**Northeast High School
Single Point of Entry
GMP-CMAR-16-003/001**

***Guaranteed Maximum Price (GMP)
Amendment 1 – Single Point of Entry***
Rev. 1 (2017-9-11)

GMP AMENDMENT 1 – SINGLE POINT OF ENTRY

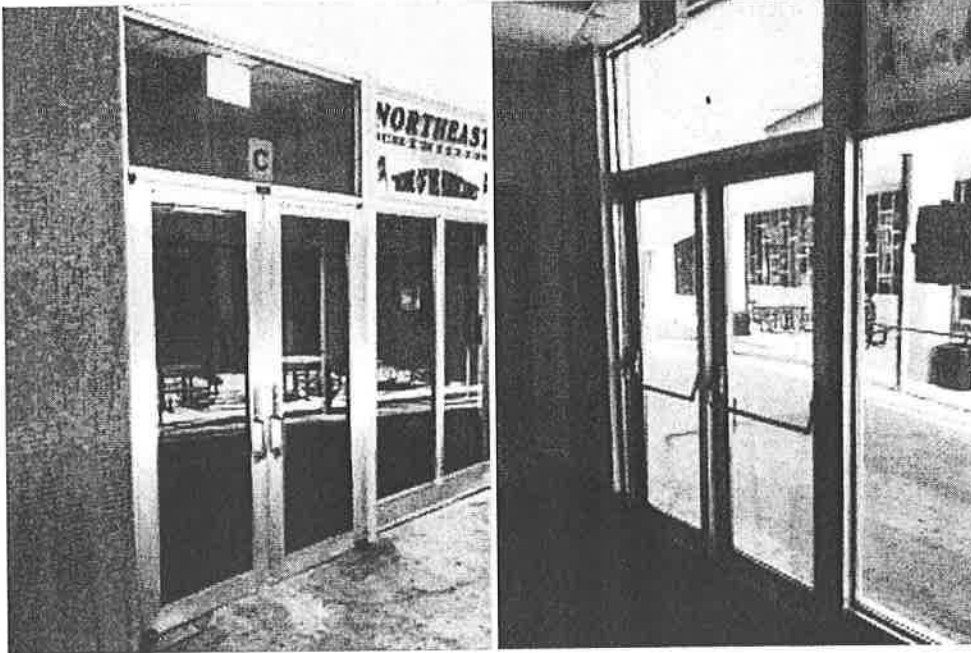
- Plan 1/A02-600 shows the replacement of doors 2.178.1, 2.177.1, 2.177.2 and 2.175. However looking at the photos included in the drawing and per site visit to the area, we noticed that doors 2.178.1 and 2.175 are not level with the sidewalk. Both of these doors have sort of a step/difference in elevation between the room floor and the exterior sidewalk. Since we are replacing these doors and therefore the replacement shall comply with applicable codes, please confirm if any concrete work such as adding a ramp, among other possibilities, is required for any of these doors.

- Elevation 2 and 3/A04-600 include only the door frame of two storefront doors that shall be replaced for doors 4.201.1 and 4.201.2. In the elevation only the door frame, doors and hardware are shown to be replaced. However, per site visit to the facility, we noticed that this will not be possible and a complete replacement of door frame including a glass piece above the door will be required since this is a complete assembly. Please confirm this information and provide respective details in the drawings. Attached photos of the area for your reference.

- The doors are at mechanical rooms and do not require ramp access.
- The storefront doors will require door and clerestory to be replaced. NOA attached.

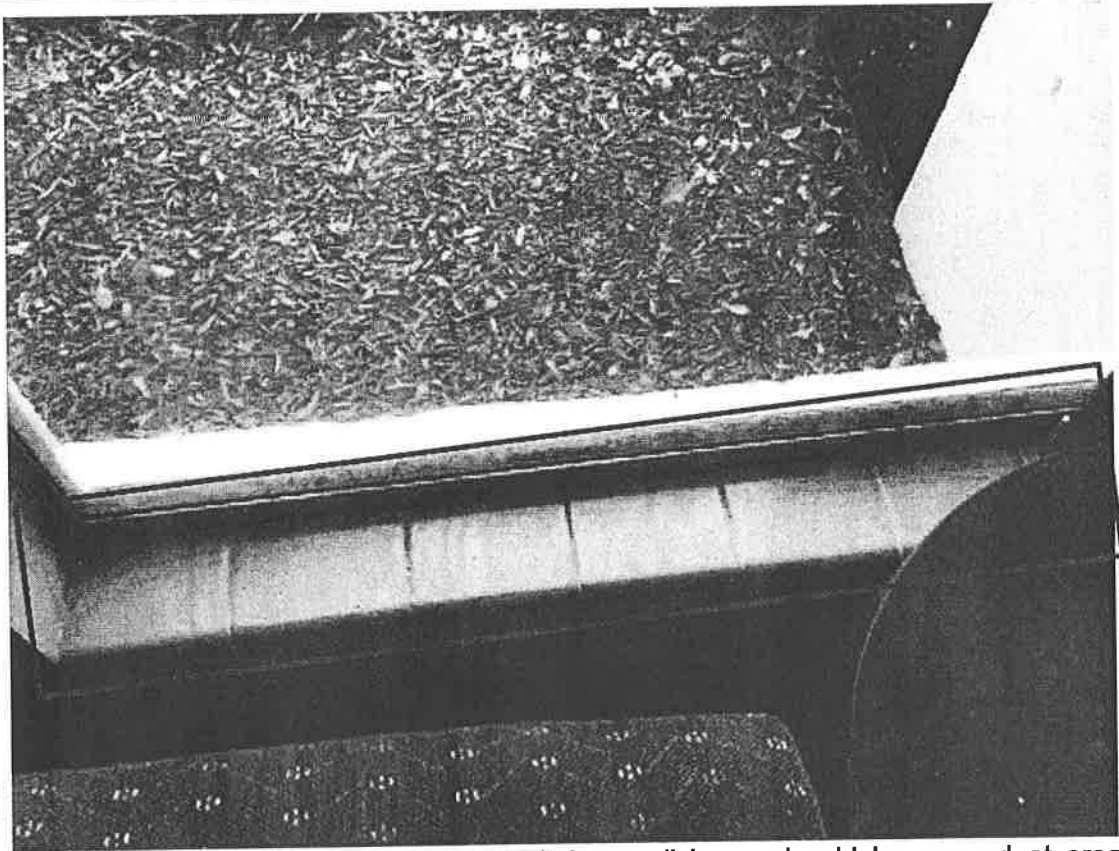
1. At the waiting area 101 in the reception, there is an existing acoustical ceiling system. Drawings do not indicate replacement of the existing system at any areas. Please confirm that modification to the existing ceiling is acceptable.
2. W1 window – it was noticed that the existing windows have ceramic tiles installed at the interior of the reception area as shown in the attached photo. During the site visit it was confirmed that we need to follow this detail for the new window. Please add a detail for our reference and confirm the ceramic tile that we need to match.

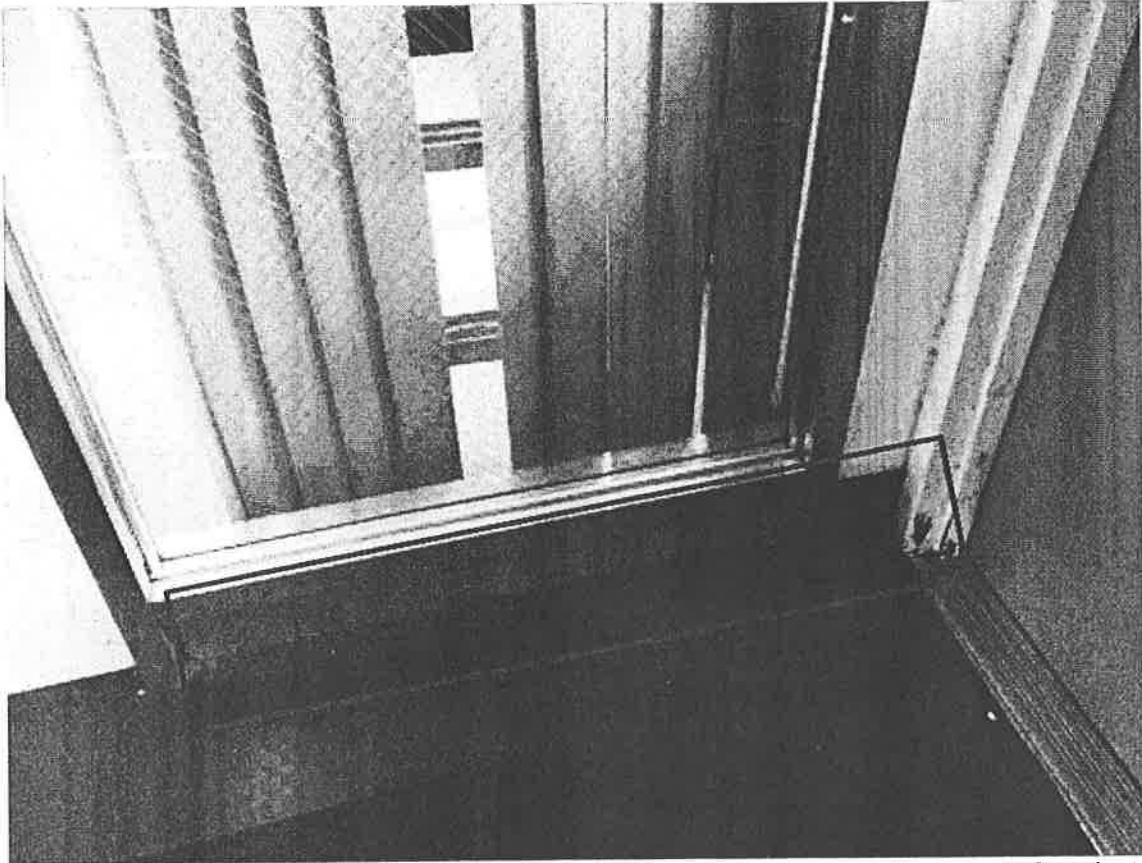
3. Wall base – it was confirmed that existing wall base should be reused at areas where new walls are been installed or modified. Also it was mentioned that the new wall between the egress corridor and the reception area, we need to match the existing rubber base as shown in photo attached. Please confirm and provide information about this base.

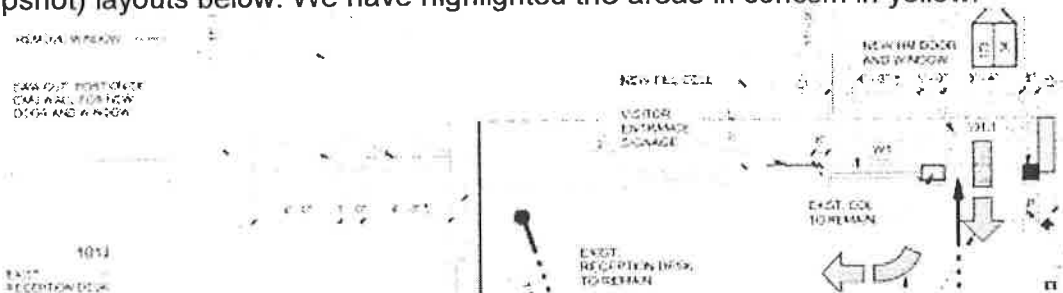
4. At the north wall located at the waiting area 101 in the reception, please confirm that when the new CMU wall is built, we will continue the gypsum furring to match the existing wall thickness. Refer below to existing (left snapshot) and new (right snapshot) layouts below. We have highlighted the areas in concern in yellow.

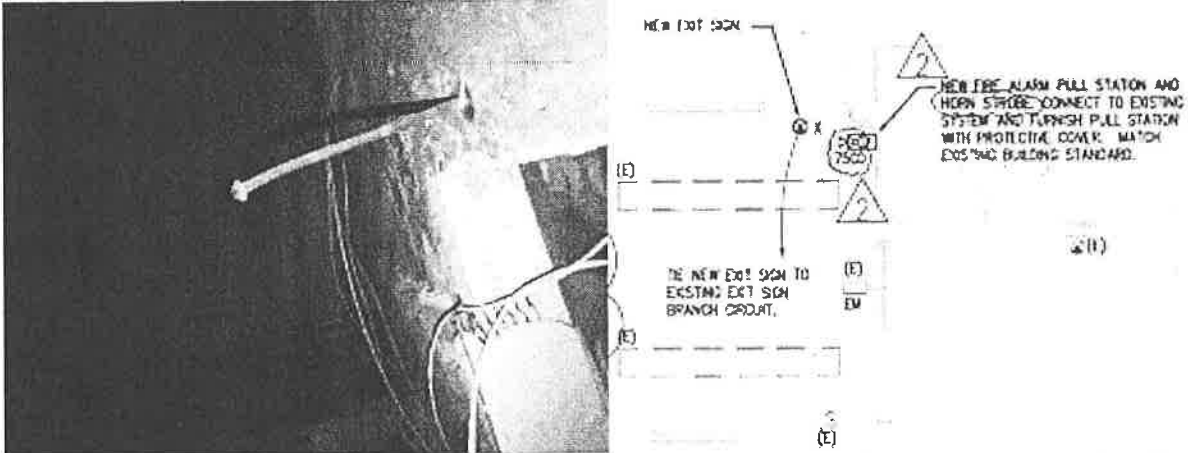
5. Drawing E-201 shows a new fire alarm pull station and horn strobes to be installed at the east wall of the waiting area 101 in the reception. During the site visit, it was noticed that this is a concrete wall with gypsum compound finish. Please advise what will be done to ensure proper installation of these devices. Installation of gypsum furring was discussed during the site visit. Take in consideration the existing ceiling type for any recommendations. Refer to photo of the wall above the ceiling

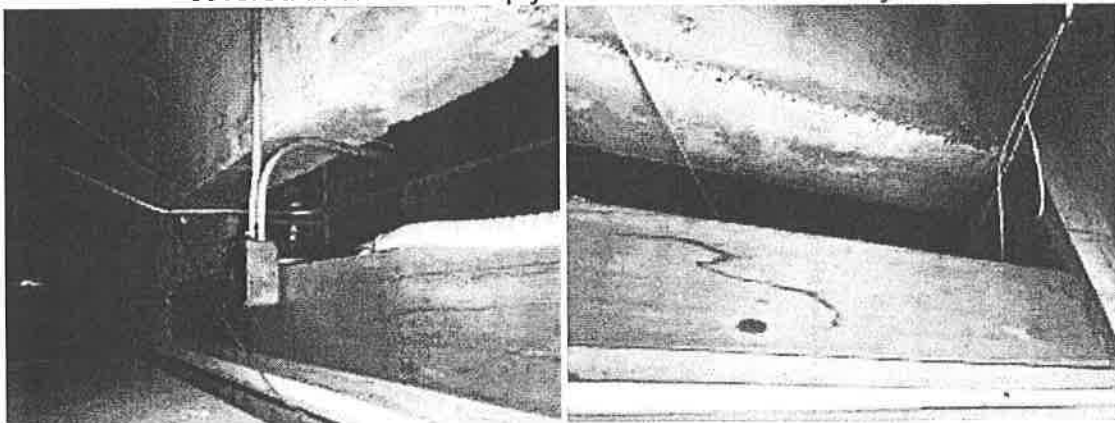
6. Existing wall where door 101.2 is located is a cast-in-place concrete wall with an opening for the existing aluminum door and window partition. The opening extends over the acoustical ceiling level as shown in the attached photos. We need the following confirmation:
- New fire rated gypsum partition type C1 will extend to cover this existing opening.
 - Finish at the egress corridor side will be cement plaster to match the existing finishes.
 - What needs to be done with existing utilities (i.e. cables without conduits, flexible conduits, among others) passing thru this opening that will be covered in order to comply with a fire rated assembly.

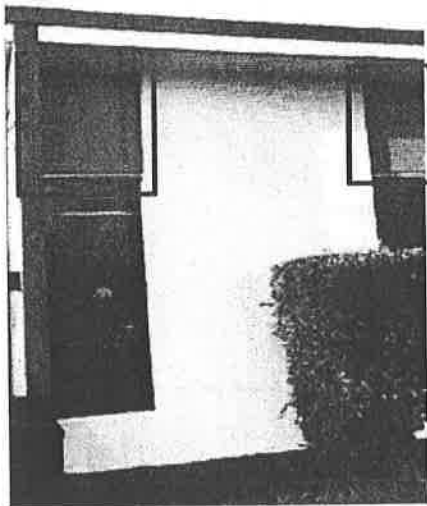
7. Building 1 Main Entry Façade – it was mentioned that the existing reveals or extrusions at the window locations shown in below photo will not be followed during the construction and stucco of the new CMU wall. Please confirm this information.

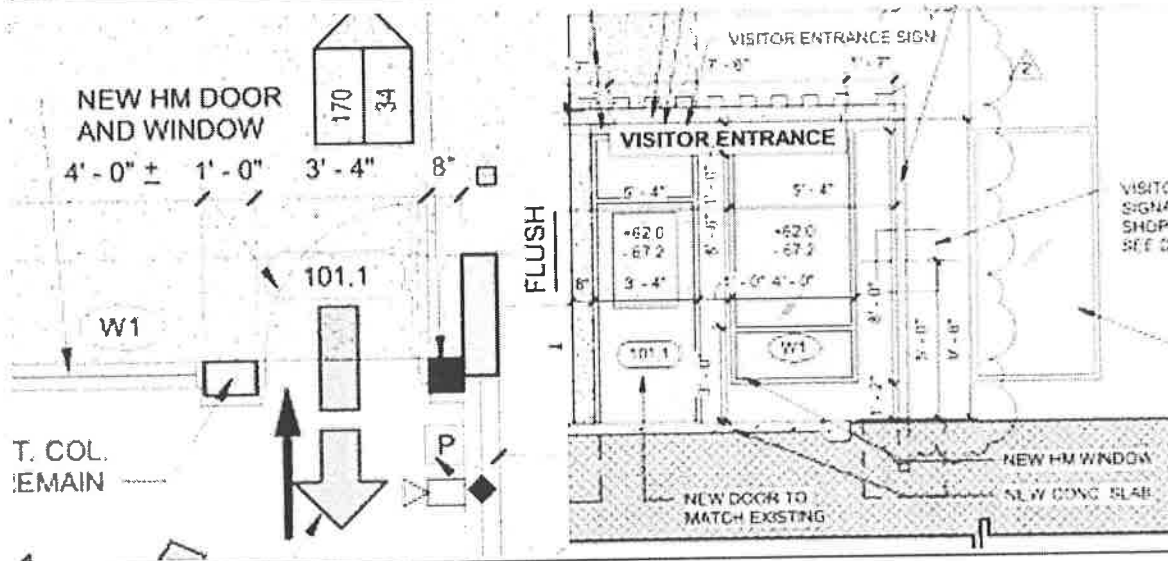
- Plan 1/A01-101 is indicating "NEW HM DOOR". Elevation 1/A01-102 is indicating "NEW DOOR TO MATCH EXISTING". Door Schedule included in drawing A01-102 is indicating that the door material is "STEEL". However, in the comments for this door in the door schedule (included as part of the review #2 of the drawing dated 05.17.17) it is making reference to NOA #14-0225.02. This NOA is for a "351 Series" Outswing Aluminum Entrance Door w/wo Transom – LMI. Please confirm material for door 101.1 and if different than aluminum, please provide correct NOA to be followed.

- Plan 1/A01-101 is indicating "NEW HM WINDOW". Elevation 1/A01-102 is indicating "NEW HM WINDOW". Window Schedule included in drawing A01-102 is indicating that the window material is "ALUM" (aluminum). NOA #15-0512.12 been referenced in the comments section of the window schedule is for a Series "410" Aluminum Fixed Window – LMI. Please confirm that this window is aluminum and that the NOA provided is accurate.

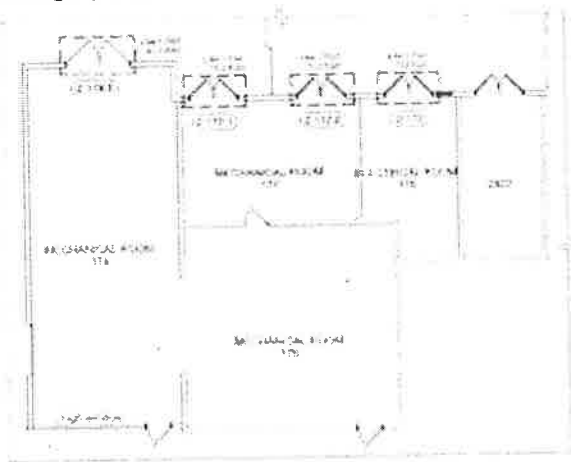
During our scope review meetings, one of our door, frames and hardware bidders indicated that they have not been able to find a door that can comply with the design pressure rating included in the drawings (-81.3 PSF) for door 2.178.1. Refer to door below:

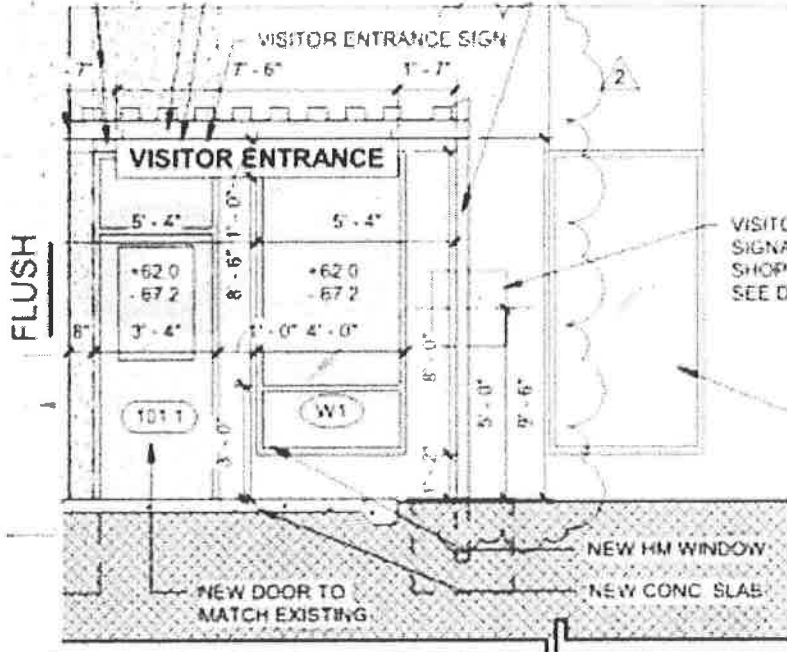
Our trade contractors have not been able to find an NOA for a single door with transom that can comply with the pressure requirements in the contract drawings for door 101.1. Please notice that the NOA provided as a response to RFI-08 (NOA 15-0930.06) only complies with +/-60PSF and door 101.1 has a requirement of +62PSF/-67.2PSF in the drawings.

One of our bidders found a door from Curries that can hold the pressures but it does not have an NOA. Refer attached to door performance information for your reference and review. Please confirm if this is acceptable or provide another solution for this door.
